SERVICE BULLETIN: JSB 016-1

Subject: J160 Family Engine Cooling

All Jabiru J160 family aircraft (All J160 & J170 models)

Figure 1 – Burnt Oil on Cylinder Head (Indicates leaking head-cylinder seal).

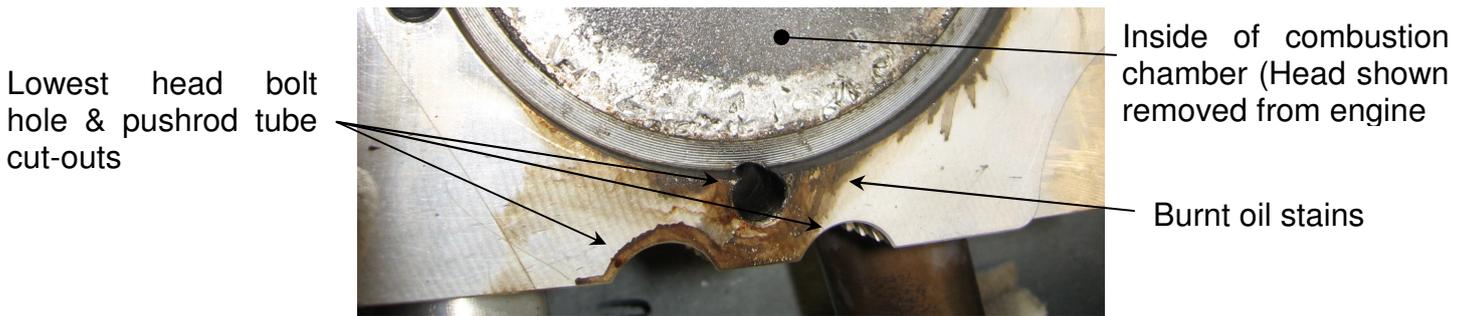
| | Score → | Never Scale Value 1 | Sometimes Scale Value 2 | Frequently Scale Value 3 |
|----------------------|---|-------------------------------|-----------------------------------|------------------------------------|
| | Cylinder to Cylinder head seal failed (burnt oil visible on rear face of lower cylinder head fins – See Figure 1). | | ✓ | |

Figure 4 – Cross Section View Through Large Cowl Lip Attachment

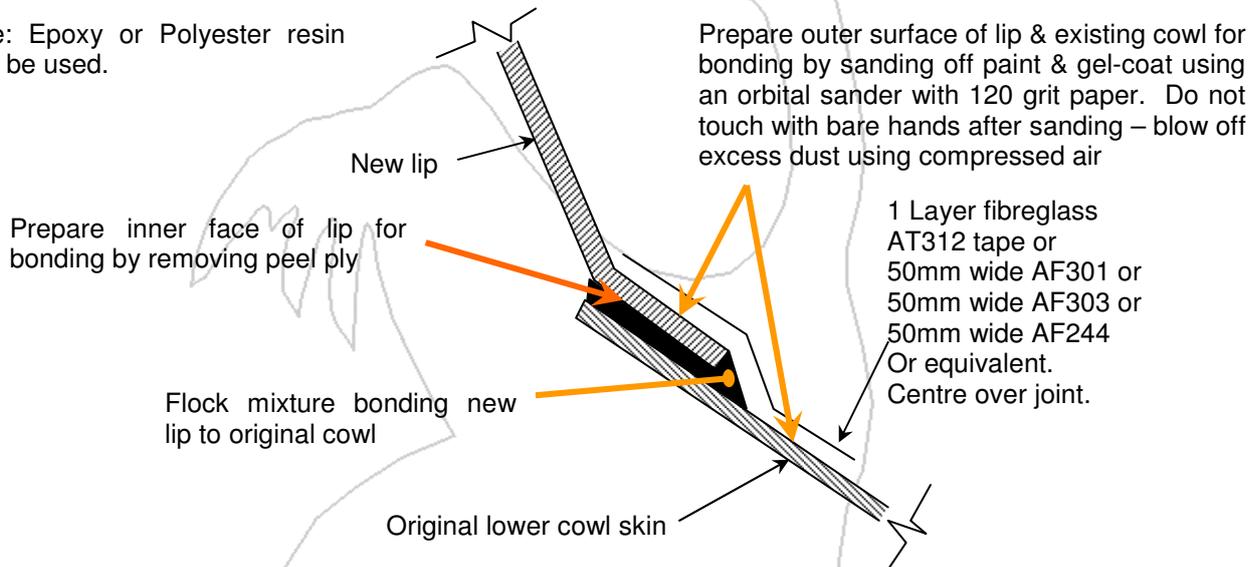
The fixed lip shown in Figures 5 is available from Jabiru Aircraft. To fit, the lip is centred on the cowl with its rearmost tips touching the rear of the cowl opening. The shape of the inside of the lip is marked out on the cowl, and the section of the cowl beyond aft of the line is cut out. The lip is then permanently attached using adhesive & a layer of fibreglass. Note that the smoothness of the transition between the original cowl and the new lip affects the efficiency of the airflow, so the newly-cut edges must be sanded to remove any rough or sharp edges.

Note: Epoxy or Polyester resin may be used.

Note: Figure 4 is shown with cowl sitting **upside down** (as shown in Figures 5 below).
